City of **HOBART**

APPLICATION UNDER HOBART INTERIM PLANNING SCHEME 2015

Type of Report:	Committee
Council:	9 April 2018
Expiry Date:	9 April 2018
Application No:	PLN-17-967
Address:	209 - 213 HARRINGTON STREET , HOBART 215 - 217 HARRINGTON STREET , HOBART ADJACENT ROAD RESERVE
Applicant:	George Walker (6ty* Pty Ltd) Po Box 63
Proposal:	Demolition and New Building for Multiple Dwellings, General Retail and Hire and Food Services, and Minor Associated Road Works
Representations:	Eight (8)
Performance criteria:	Use; Commercial Zone Use and Development Standards; Potentially Contaminated Land Code; Road and Railway Assets Code; Parking and Access Code; Historic Heritage Code

Image 3: The proposed building's Patrick Street frontage. The adjacent building at 81-83 Patrick Street can be seen dotted in to the right of the building. The elements of the proposed building above the compliant 15m height limit can be seen hatched in red at the top of the building.

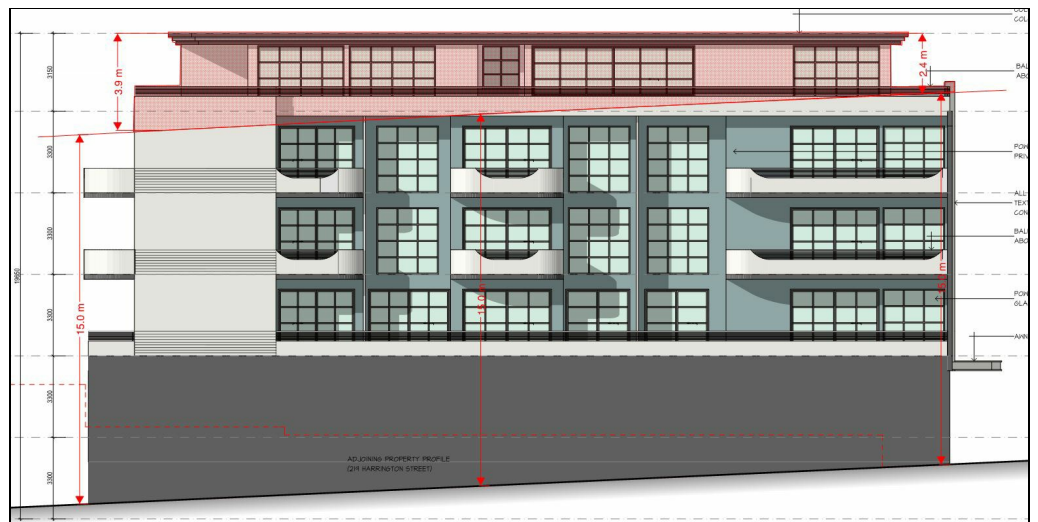
The upper part of the proposed building is to an extent stepped in from the main bulk of the building, assisting to provide transition down from its overall height to the zone's acceptable height limit. The varying degree to which the building extends above the 15m acceptable limit can be seen illustrated in the marked up plan excerpts that follow:

Simply put, if the upper floor of the proposed building was removed from its design, there would be marginal extension of building elements above the 15m height maximum but, more importantly, a negligible decrease in immediate impact upon adjacent properties due to the extent of height offset. The upper floor of the building would not be apparent when viewing the building from the adjoining property on Patrick Street, nor from the footpaths immediately adjacent the site on Patrick and Harrington Streets. It would only be discernible when viewed from slightly further vantage points and beyond when the upper elements of the building would be fully revealed, at which point any immediate impacts upon adjoining buildings would not be evident.
